Adapter cable needed at WAM for IHU Replacement

REF NO: TJ 32995.1.1	ISSUING DEPARTMENT: Technical Service	CAR MARKET: United States and Canada		
3 US 7	PARTNER: '510 Volvo Car USA	ISSUE DATE: 2017-08-31	STATUS DATE: 2017-09-08	
FUNC GROUP: 3901	FUNC DESC: Media reader; media player	Page	1 of 6

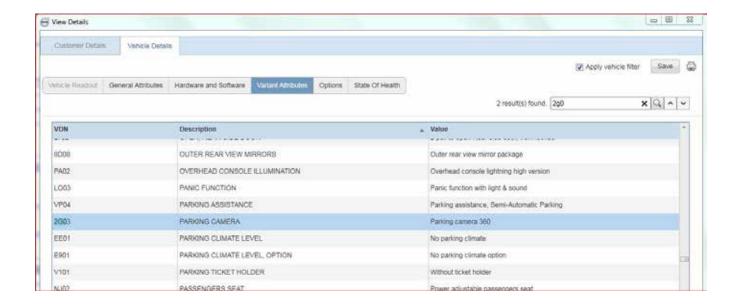
For model year 2016 XC90 with the 360 camera option (variant attribute 2G03, TJ_32995 (Variant Identifier).JPG) an extra adapter cable is needed when replacing the IHU due to a hardware change in the replacement parts.

When ordering a new IHU, adapter cable part number 31680998 must also be ordered (see attachment TJ 32995 (1).JPG).

The adapter cable must be connected in-line at connector "B" at the WAM (see attachments TJ_32995 (2).JPG and TJ_32995 (3).JPG)
